LOCKHEED AIRCRAFT CORP.		ENGINEERING STUDY <input type="checkbox"/>		CHANGE PROPOSAL <input checked="" type="checkbox"/>		LAC-98				
DATE 4-3-61		AFFECTS : WSPO <input checked="" type="checkbox"/>		PROJECT <input checked="" type="checkbox"/>						
NAME OF MAJOR COMPONENT AIRPLANE		PART OR LOWEST SUBASSEMBLY FUEL PUMP		PART NO. & MODEL OR TYPE						
TITLE OF PROPOSAL : FUEL SYSTEM REVISION										
NATURE OF PROPOSAL :  SEE PAGE 2										
REASON FOR PROPOSAL : 1. To improve reliability of the existing hydraulically driven fuel boost pump by replacing the present chip catcher with a 200 mesh strainer. 2. To reduce the possibility of engine flameout due to loss of fuel pressure particularly at high altitudes by providing an electrically driven fuel boost pump as backup for the existing hyd. driven pump. The new pump will be controlled by the pilot and is to be turned on for all operations above 50M ft.

NATURE OF PROPOSAL:

Change Proposal

### FUEL SYSTEM DIAGRAM

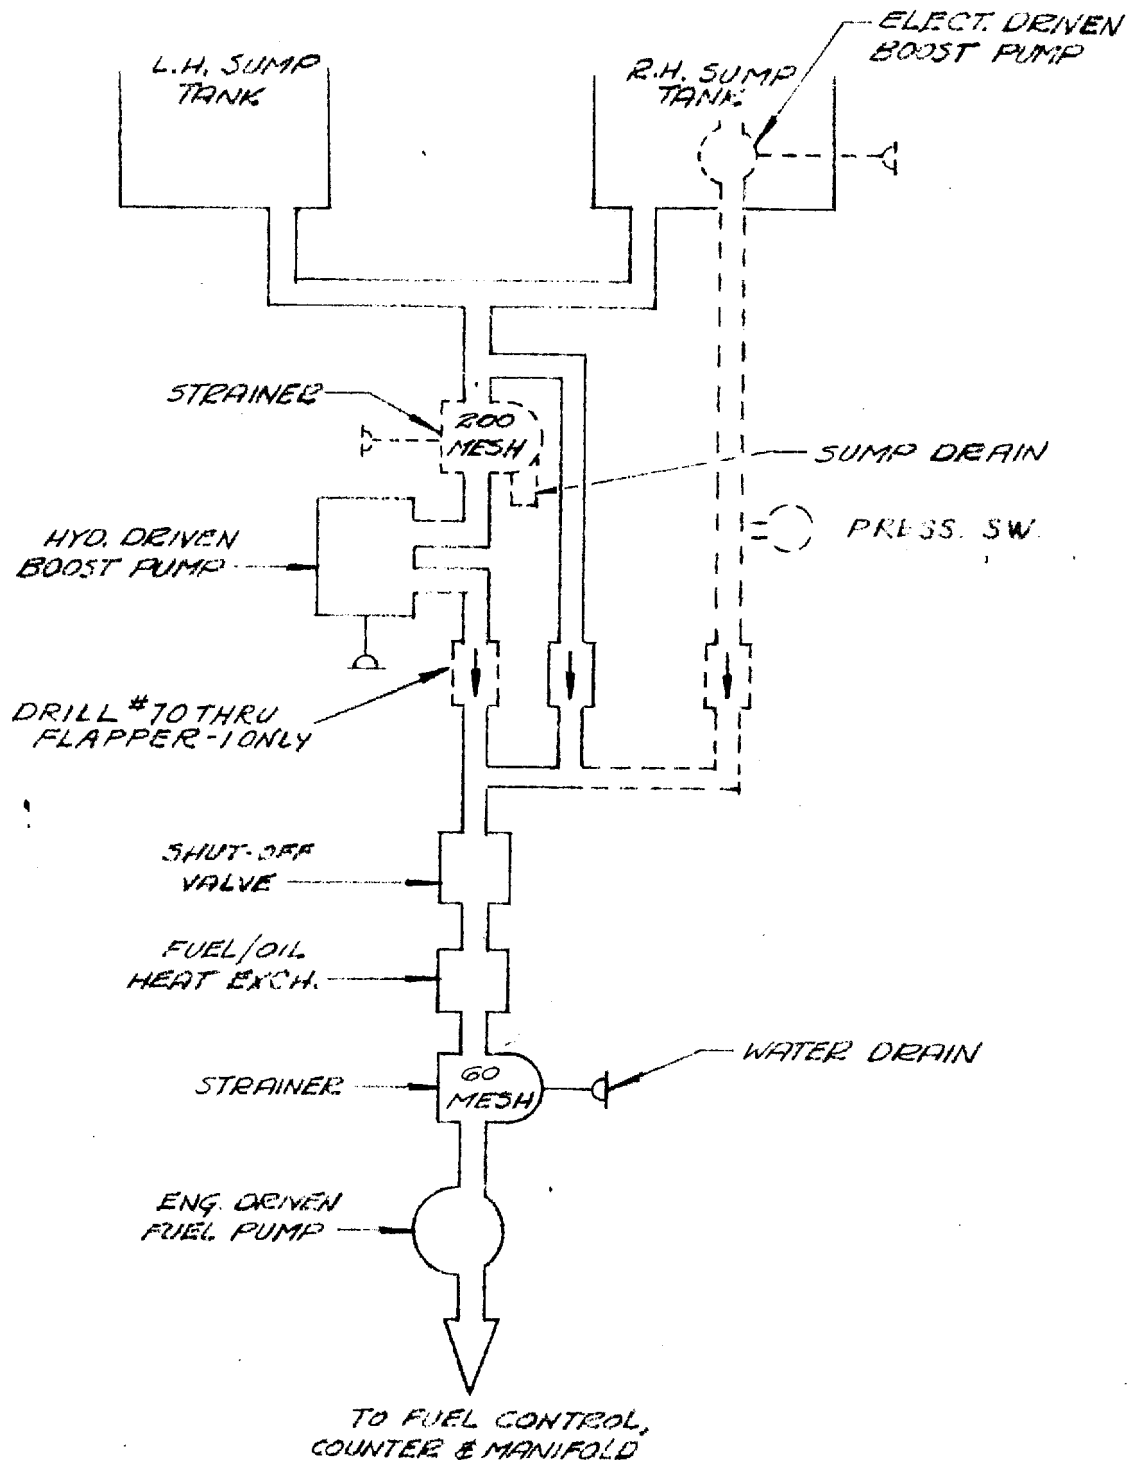
1. Modify the fuel system on all aircraft (except serials 342 & 358)\* as follows:
  - a. Replace the existing Chip Catcher (P/N H-80) with a 200 mesh strainer.
  - b. Install a submerged A.C. electric motor driven boost pump in the right-hand sump tank. Install related plumbing to connect pump in parallel with the existing boost pump and bypass line. This includes the addition of two new check valves; one in each boost pump fuel out line, and a pressure switch between the check valve and the new pump (see attached diagram).
  - c. Replace the existing sump tank overflow light in the cockpit with a fuel pressure indicator light (elec. boost pump only) and install pilot's control switch. Install power relay on Q-bay "CB & Relay" panel and install system wiring.
  - d. On all aircraft remove the overflow float switch from the sump tanks.

SHOWING ADDED ELECTRICALLY DRIVEN  
 SUBMERGED BOOST PUMP & 200 MESH STRAINER
